Replacement Thermostat Housing 57/23

Vehicle Type: **Cayenne (9PA1)**

Concerns: **All models with V8 engines, (M4801, M4851)**

Overview

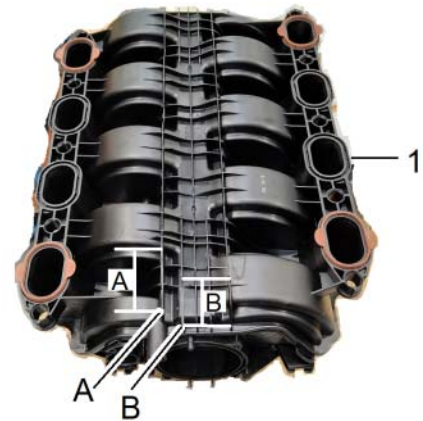
Variant A: 948.106.060.06 Thermostat housing (threaded pipes)

Variant B: 948.106.060.05 Thermostat housing (bonded pipes)

Part Info: Thermostat housing, new version: **948 106 060 06** (threaded connection tubes)
old version: 948 106 060 05 (bonded connection tubes)

Bar A/B

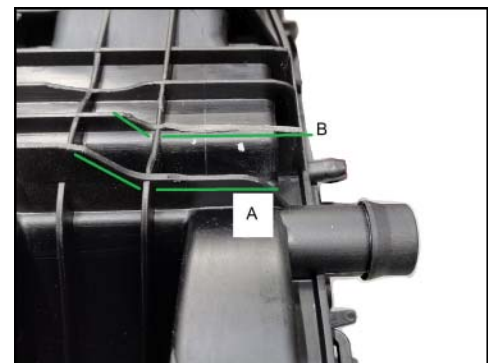
Mill off two bars on the intake distributor by following the contours A and B ⇒ *Contour*

Install new thermostat housing.

Check for sufficient space between thermostat housing and intake distributor:

Place a sheet of paper between the housing and intake distributor.

If there are strong pressure traces on the paper, it must be improved.
